Product Change Notification

Change Notification #: 111416 - 00

Change Title: Intel® Desktop Board D2500CC and D2500CCE, Boxed and Bulk PCN 111416-00, Product Material, Supplier change for Clock Generator and SM PWM IC and BIOS Update

Date of Publication: April 2, 2012

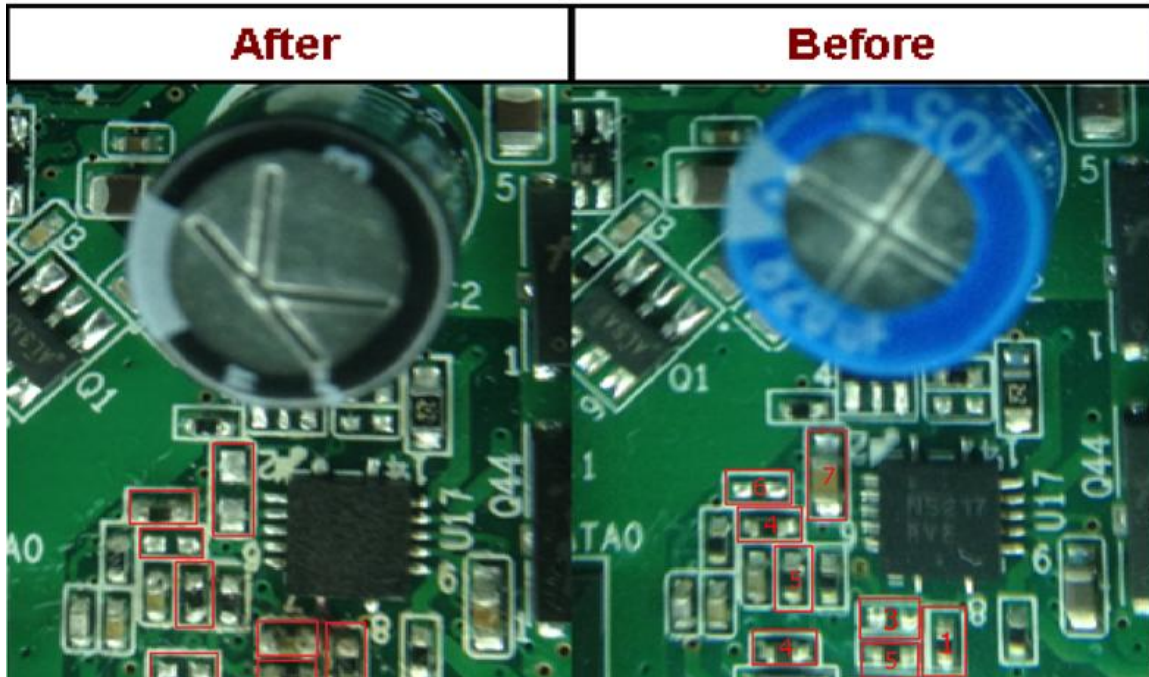
1. BIOS update from CCCDT10N.86A.0030 to CCCDT10N.86A.0032. To access the release notes or get a copy of the BIOS for evaluation, go to <http://downloadcenter.intel.com>.
2. Replace the clock chip with a Silego* part in order to improve supply availability.
